DC3303-L2 – Addendum to Noise Impact Assessment – Revisions to Site Layout – Balne Croft Farm, Pollington

Dragonfly Consulting has been instructed to undertake a revised noise impact assessment with respect to the proposed wedding events venue at land belonging to Balne Croft Farm, Pollington ('The Site'), following alterations to the proposed site layout subsequent to submission of the original assessment (ref. DC3303-R1v3, issued 7th May 2020).

Figure 1
Revised Barrier Dimensions

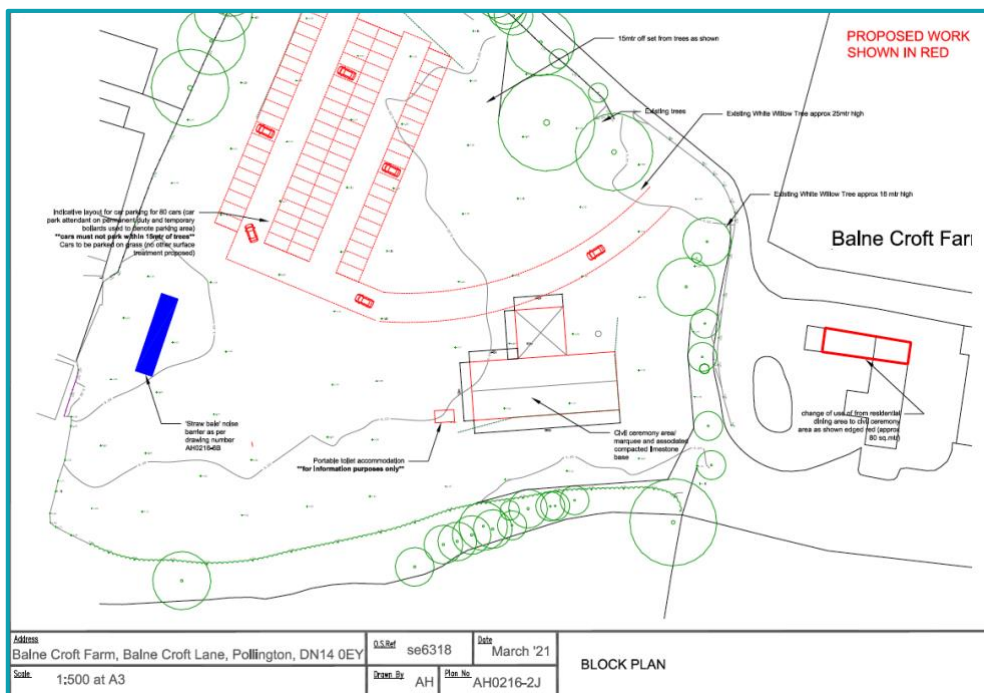
Further to this, it is understood that the proposed barrier along the western boundary of the site is required to be relocated due to concerns surrounding fire risk and structural integrity; as such, a revision to the barrier position and layout is proposed to comply with the requirement of a separation distance three times the barrier height from any nearby structures. Adjustments to the construction methodology for the purposes of structural rigidity have resulted in the bale wall shown in Figure 1 overleaf:

Figure 2
Revised Site Layout

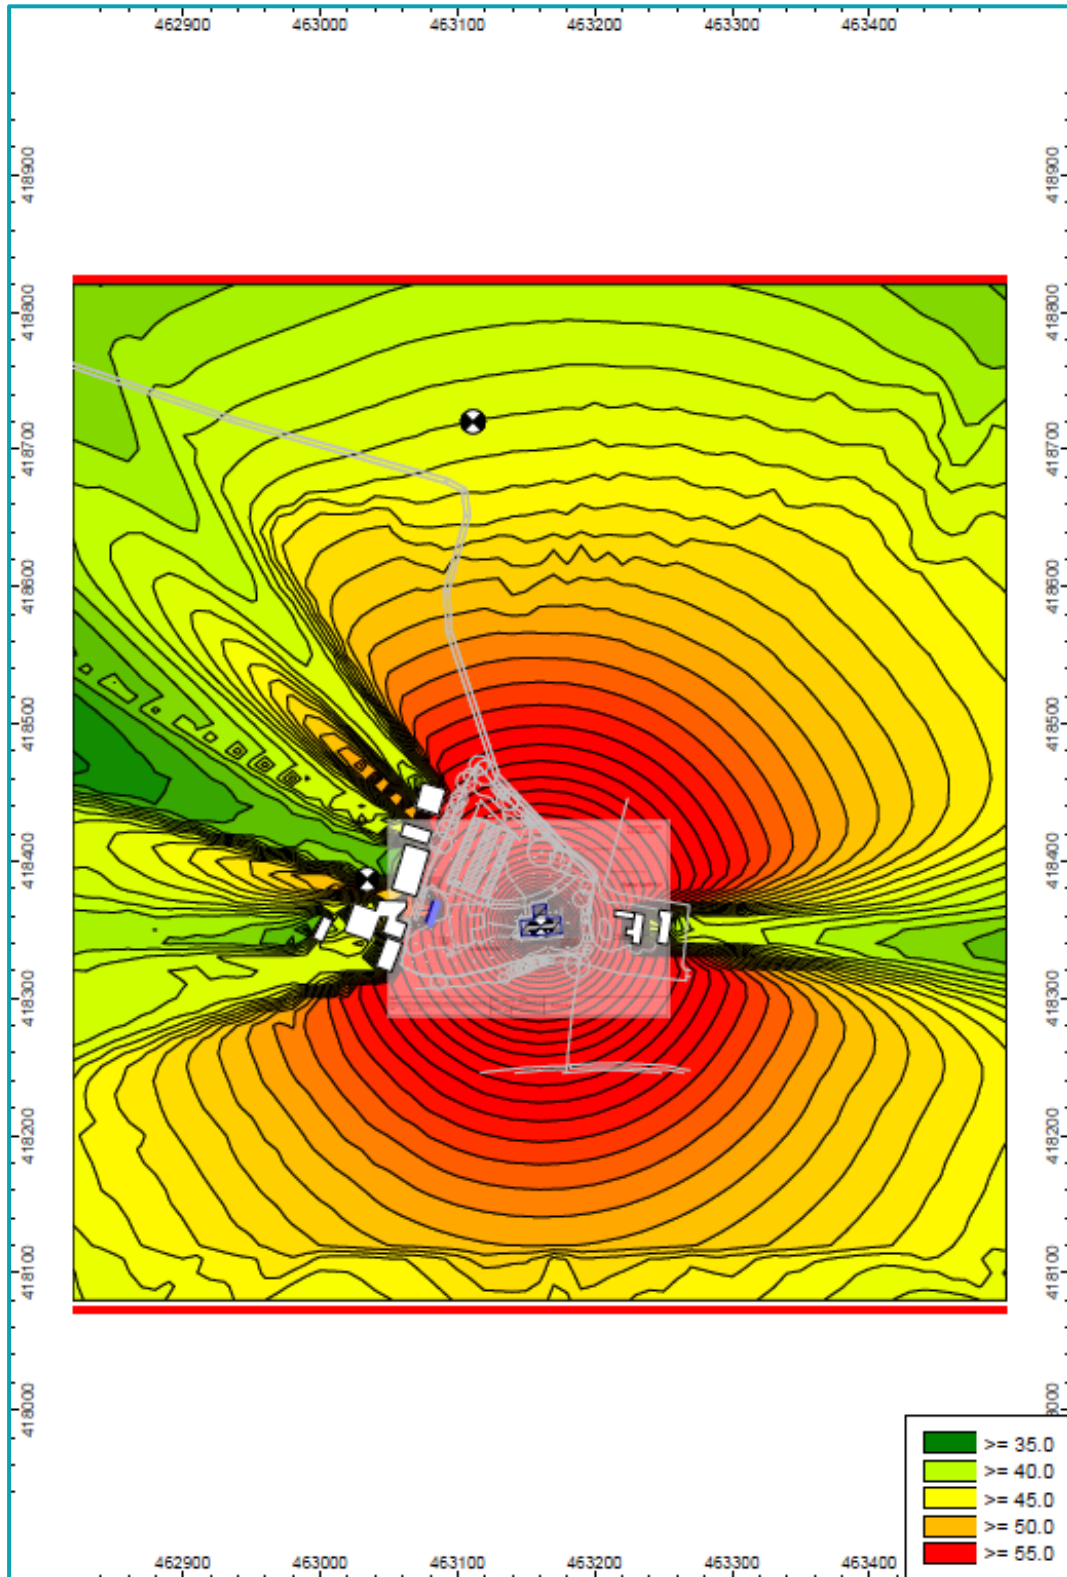
Due to non-acoustic factors that have arisen in further discussions following approval of the planning application, it is understood that the marquee is to be rotated and repositioned approximately 35m nearer to the south-eastern corner of the site.

A revised site layout has been provided by Pearce & Pearce Architectural Design and is replicated in Figure 2 below:
